**HISTORIC AND DESIGN REVIEW COMMISSION
COMPLIANCE AND TECHNICAL ADVISORY BOARD**

HDRC CASE NO:	2024-143
ADDRESS:	117 SWEET
LEGAL DESCRIPTION:	NCB 2559 BLK B LOT E 30 FT OF 14 & W 30 FT OF 15
ZONING:	RM-4, H
CITY COUNCIL DIST.:	1
DISTRICT:	Nathan Historic District
APPLICANT:	Julio Vazquez /Payaya Design & Build
OWNER:	MOOD MICHAEL G & LYONS DEIRDREA A
TYPE OF WORK:	Fenestration modification
APPLICATION RECEIVED:	March 28, 2024
60-DAY REVIEW:	May 27, 2024
CASE MANAGER:	Claudia Espinosa

REQUEST:

The applicant is requesting a Certificate of Appropriateness for approval to modify an existing window opening on the front façade by converting the existing opening to a door opening.

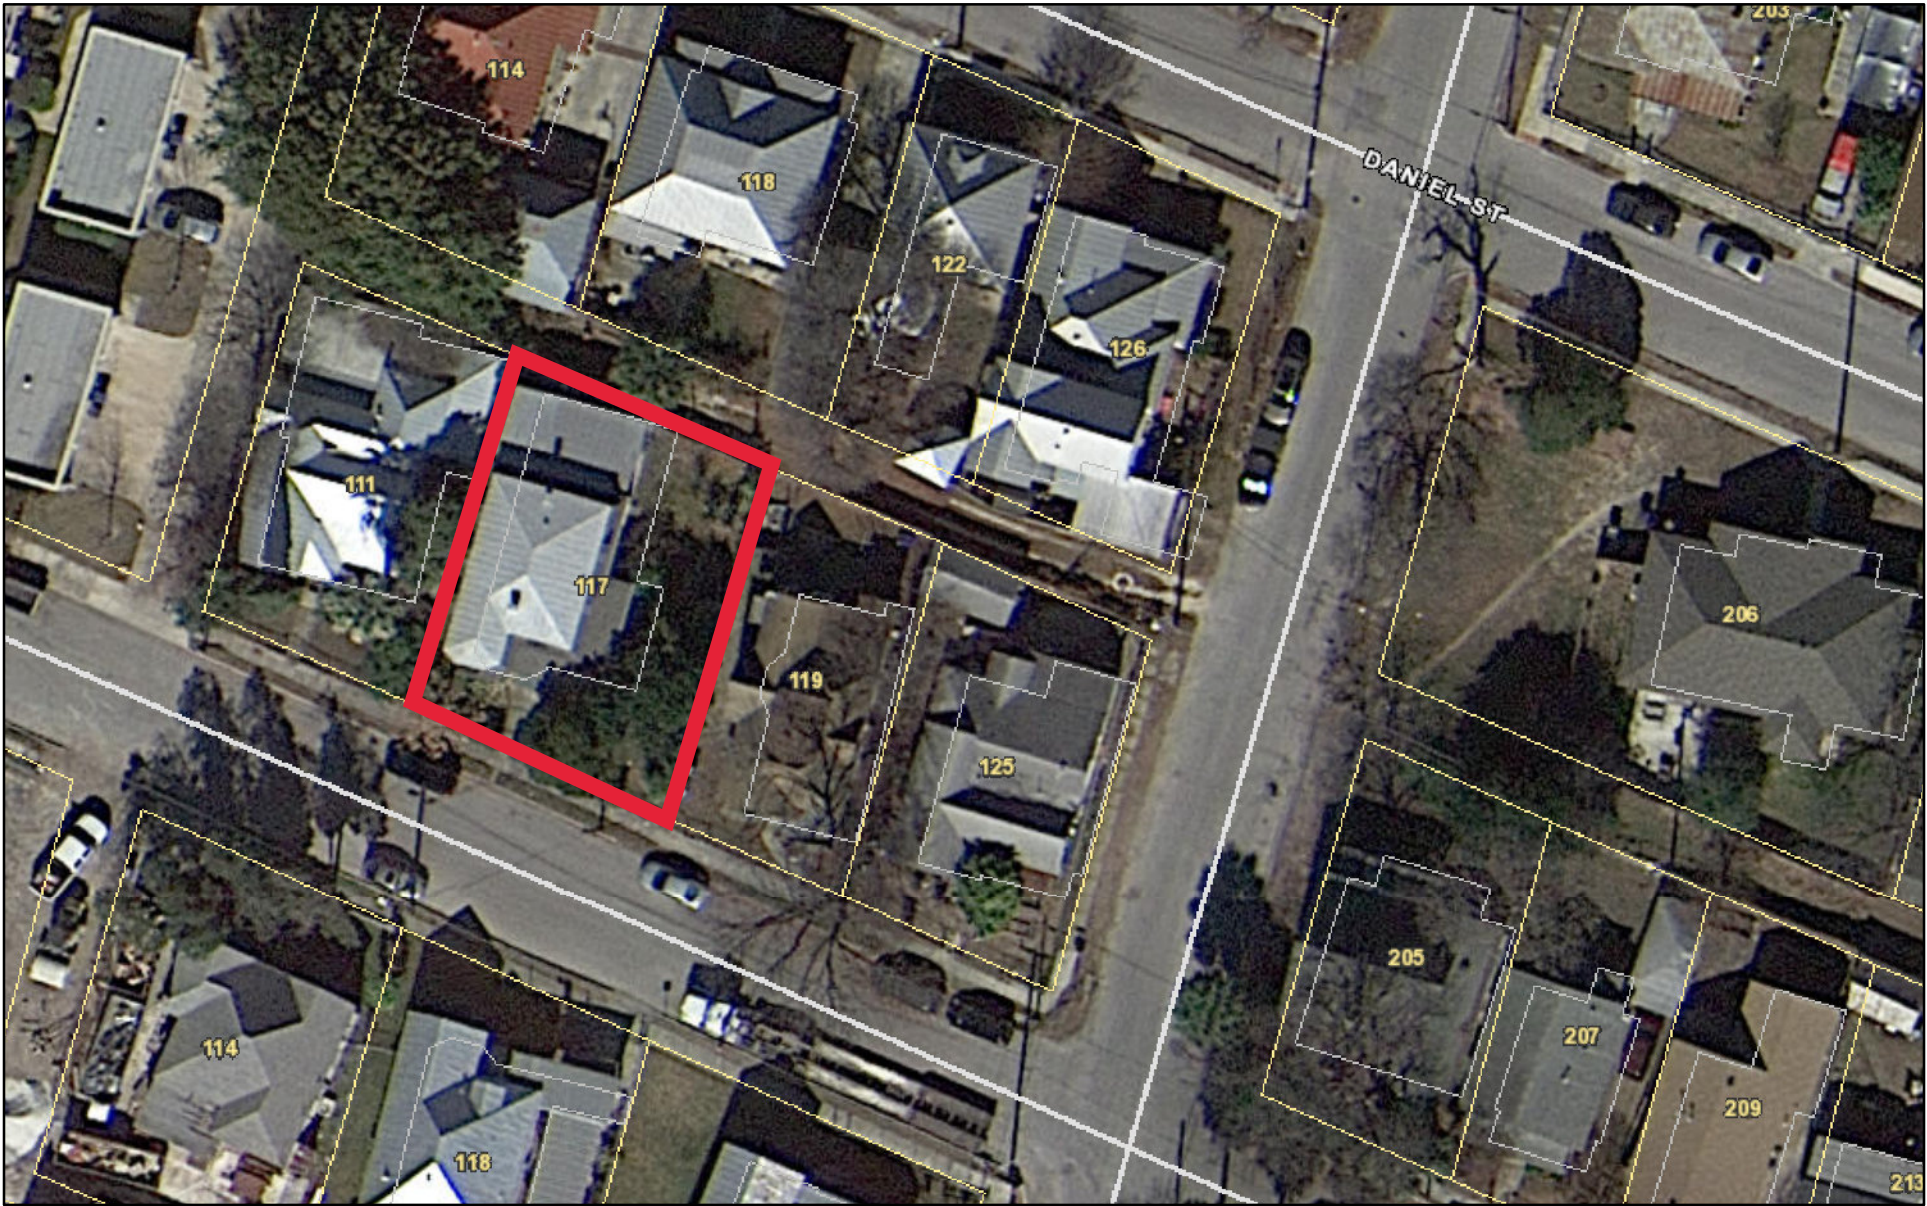
a. The historic structure at 117 Sweet was constructed circa 1910 in the Folk Victorian style and makes its first appears on the 1912 Sanborn Map. The structure features wood lap siding, one-over-one wood windows, a wrap around front porch and a Mansford roof with small dormers. The structure is contributing to the Nathan Historic District.

b. FENESTRATION MODIFICATION – The applicant has proposed to convert the existing window opening to a door opening. Per the Guidelines for Exterior Maintenance and Alterations 6.A.i. original window and door openings should be preserved. Additionally, the Guidelines note that applicants should avoid creating new primary entrances or window openings on the primary façade or where visible from the public right of way. Staff finds the proposed conversion from a window opening to a door opening to be inconsistent with the Guidelines for Exterior Maintenance and Alterations. Staff finds that the original window opening should be retained.

Staff does not recommend approval of the fenestration modification based on finding b.
